**Mount Tipton
Water Co, inc.**

RE: Docket W-02105A-07-0510
ADEQ Report 123663

In reference to ADEQ Report Inspection ID # 123663

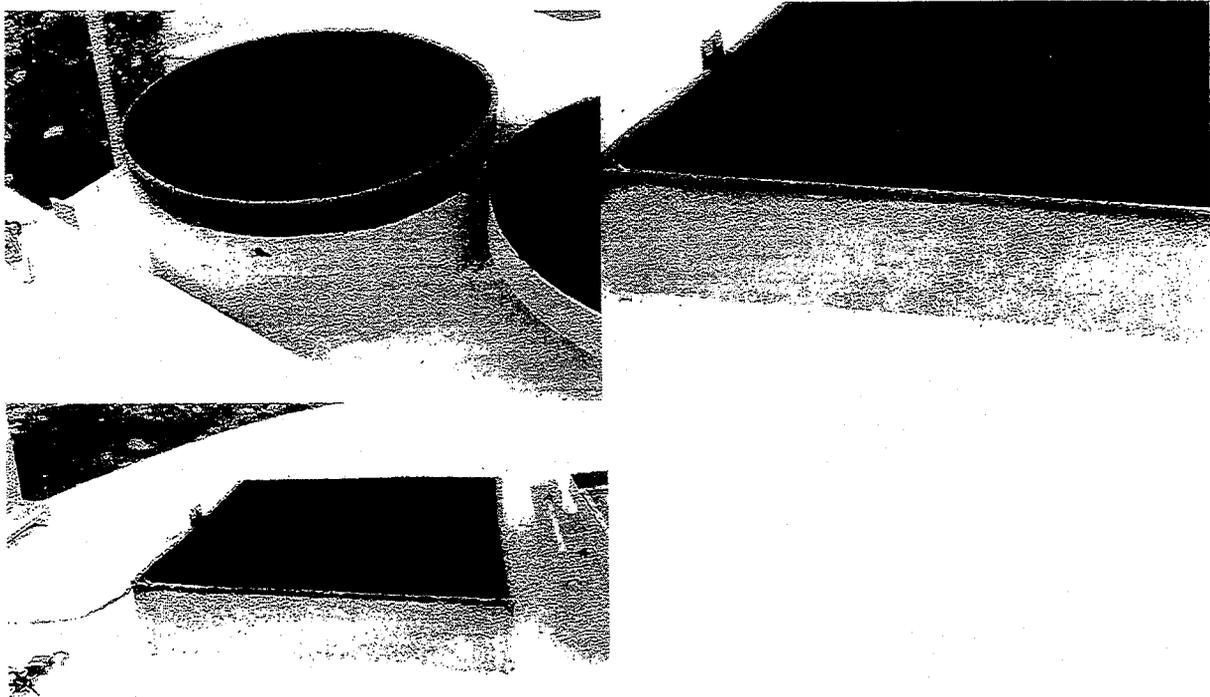
4. ADEQ requests that you replace the missing block and repair the tank bedding on the mid-range tanks.

Item #4 in your list. The block on the corner of this picture was replaced and cemented in. This was not at the midrange tanks but at the Dolan Tanks.

This is the rubber grommet installed on the Dolan Tanks. The round hatch is the front tank and the square hatch is the back tank.

**RE: Mt. Tipton Water Company – Detrital Well Piping & Restraint Modification
ADEQ File Number: 980242**

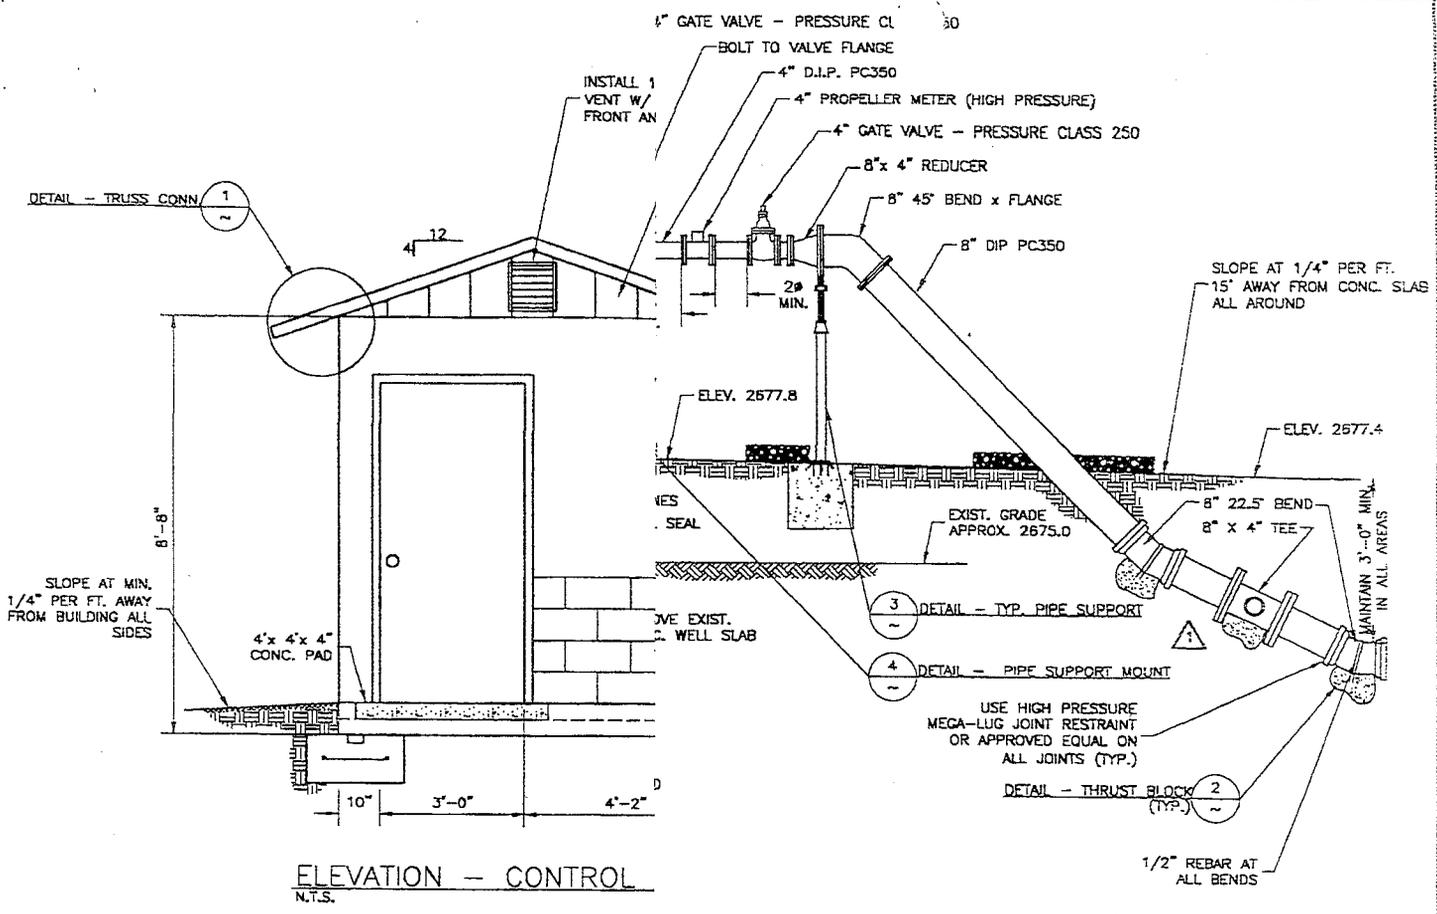
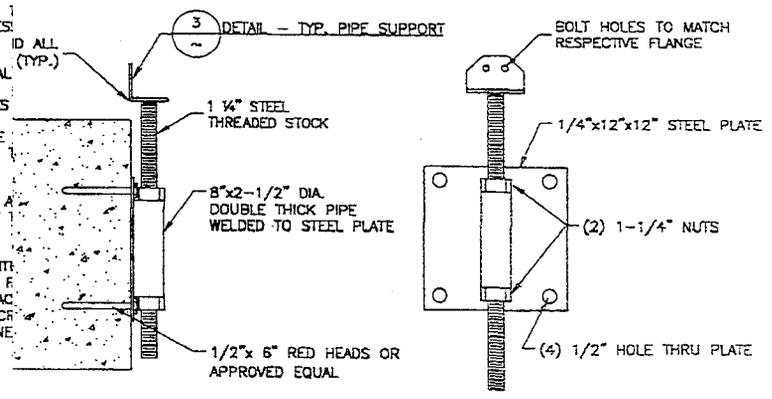
An inspection performed by this office found that the piping assembly is failing and needs to be reinstalled and properly thrust blocked if necessary. The response by the engineer that the problem may be fixed under a future project is not acceptable. Please fix the problem.

Please provide disinfection method and results for well and pipe assembly as per bulletin No. 8. In addition, an inspection performed by this office found that the piping assembly is failing and needs to be reinstalled and properly thrust blocked.

Enclosed is a copy of a drawing showing a modification to the original record drawing in the area of the bends and thrust blocks as the supply line enters the ground and the proposed modification to the well pipe support to eliminate the pipe deflection at the well head. In further discussion with Technology Construction, Inc. (Contractor for the project) they indicated that due to site layout constraints they modified the piping layout as shown on the enclosed drawing. This layout included two 22 1/2° bends instead of the original 45° bend to accommodate the tee to the standpipe. In addition, the Contractor installed U-shaped 1/2" rebar over each of the fittings into the thrust blocks below to provide restraint in the vertical direction. The Contractor also used mega-lug restraints on all fittings.

Evidently this arrangement has still allowed some deflection of the well piping at the well head. This has been stopped by the addition of a restraint at the well head. However, as per our last discussion, this method of restraint is not acceptable to ADEQ. Therefore, we are proposing the restraint shown in the lower right-hand corner of the enclosed drawing. This restraint would be attached to the existing concrete base surrounding the well head. The proposed restraint would provide total restraint for the well piping by being fastened to the concrete base and into the flange of the piping. Once this restraint is in place, the current restraint at the well head will be removed.
